UNITED STATES PATENT AND TRADEMARK OFFICE

APPLICATION NO.	FILING DATE	FIRST NAMED INVENTOR	ATTORNEY DOCKET NO.	CONFIRMATION NO.
10/538,943	06/13/2005	Tetsuya Komoguchi	09792909-6283	6002
26263 7590 01/28/2008 SONNENSCHN NATH & ROSENTHAL LLP P.O. BOX 061080 WACKER DRIVE STATION, SEARS TOWER CHICAGO, IL 60606-1080			EXAMINER TRAN, TAN N	
			ART UNIT 2826	PAPER NUMBER
			MAIL DATE 01/28/2008	DELIVERY MODE PAPER

Office Action Summary

DETAILED ACTION

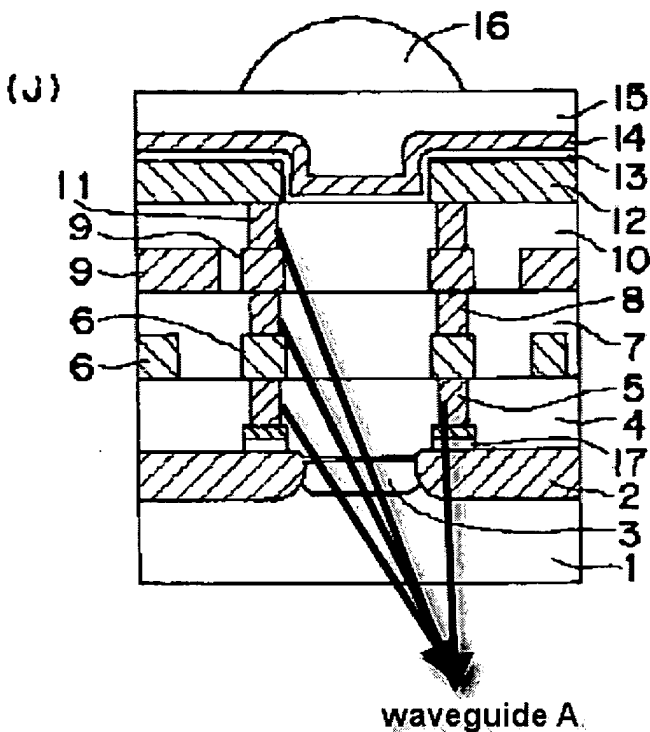
Claim 1 is rejected under 35 U.S.C. 102(b) as being anticipated by Kawasaki (JP-2001-267544).

With regard to claim 1, Kawasaki discloses a plurality of light-receiving sections 3 (it is inherent that Kawasaki disclose a plurality of light-receiving sections in order to provide array of solid-state image pickup device formed on the same substrate) and which generate charge in response to incident light (because sections 3 are the light-receiving sections); a insulating layer 4 functioning as a planarizing layer which covers predetermined elements 15 disposed on the substrate 1 to perform planarization [paragraph 0033, lines 10-13]; a plurality of signal lines (6,9) disposed above the planarizing layer (layer 4); a waveguide (A as shown in the attached fig.) which guides incident light to each of the light-receiving sections 3 (see fig. 1A, and attached fig.), the waveguide (A as shown in the attached fig.) passing through the space between the plurality of signal lines (6,9). (Note see attached fig. and figs. 1A, 9J of Kawasaki).

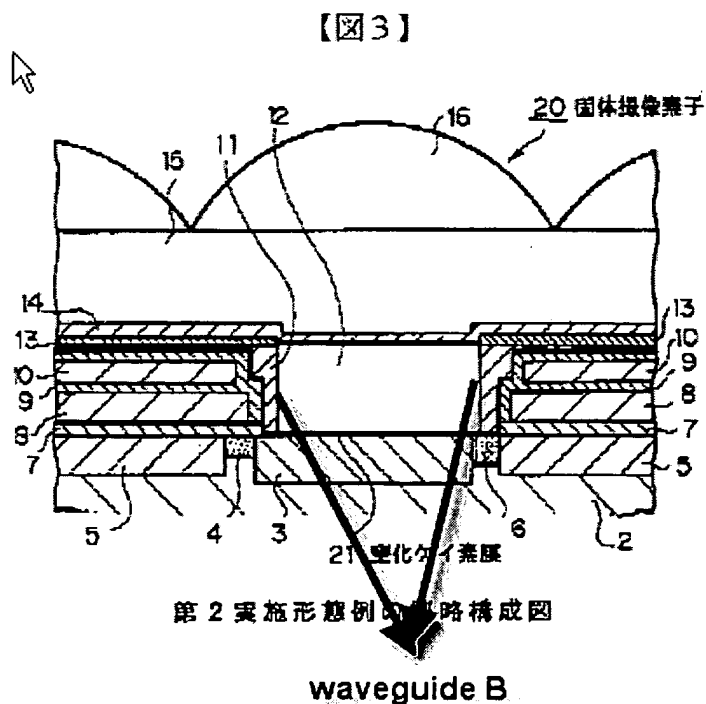
Claims 19-23 are rejected under 35 U.S.C. 103(a) as being unpatentable over Kawasaki (JP-2001-267544) in view of Fukusho (JP-10-326885).

With regard to claims 19,20, Kawasaki is silent that the waveguide comprises a light-transmissive film having a relatively high refractive index, the light-transmissive film being embedded in a hole formed by an insulating film having a relatively low refractive index, the

light-transmissive film includes a first material portion containing at least hydrogen wherein the first material portion comprise silicon nitride.

However, Fukusho discloses the waveguide (B as shown in the attached fig) comprises a light-transmissive film (transparent film 12) having a relatively high refractive index (lines 7-12 of Abstract in the translation), the light-transmissive film (transparent film 12) being embedded in a hole formed by an insulating film 11 having a relatively low refractive index (lines 7-12 of Abstract in the translation), the light-transmissive film (transparent film 12) includes a first material portion containing at least hydrogen wherein the first material portion comprise silicon nitride (lines 11,12, paragraph 0022, fig. 3 of Fukusho). (Note see attached fig. and fig. 3 of Fukusho).

With regard to claims 21-23, Kawasaki is silent that an etching stopper film for forming the hole is provided on the upper surface of a gate-insulating film on the light-receiving section, the first material portion is in contact with the gate-insulating film through an opening of the etching stopper film; Wherein the etching stopper film comprise silicon nitride formed by low-pressure CVD and at least the etching stopper film extends to above transistor region provide in the substrate in the periphery of the light-receiving section.

However, Fukusho discloses an etching stopper film 21 for forming the hole is provided on the upper surface of a gate-insulating film 7 on the light-receiving section 3, the first material portion is in contact with the gate-insulating film 7 through an opening (where transparent material 12 forming in the etching stopper film 21) of the etching stopper film 21; Wherein the etching stopper film 21 comprise silicon nitride formed by low-pressure CVD (lines 6,7, paragraph 0023) and at least the etching stopper film 21 extends to above transistor region 5 provide in the substrate 2 in the periphery of the light-receiving section 3. (Note see attached fig. and fig. 3 of Fukusho).
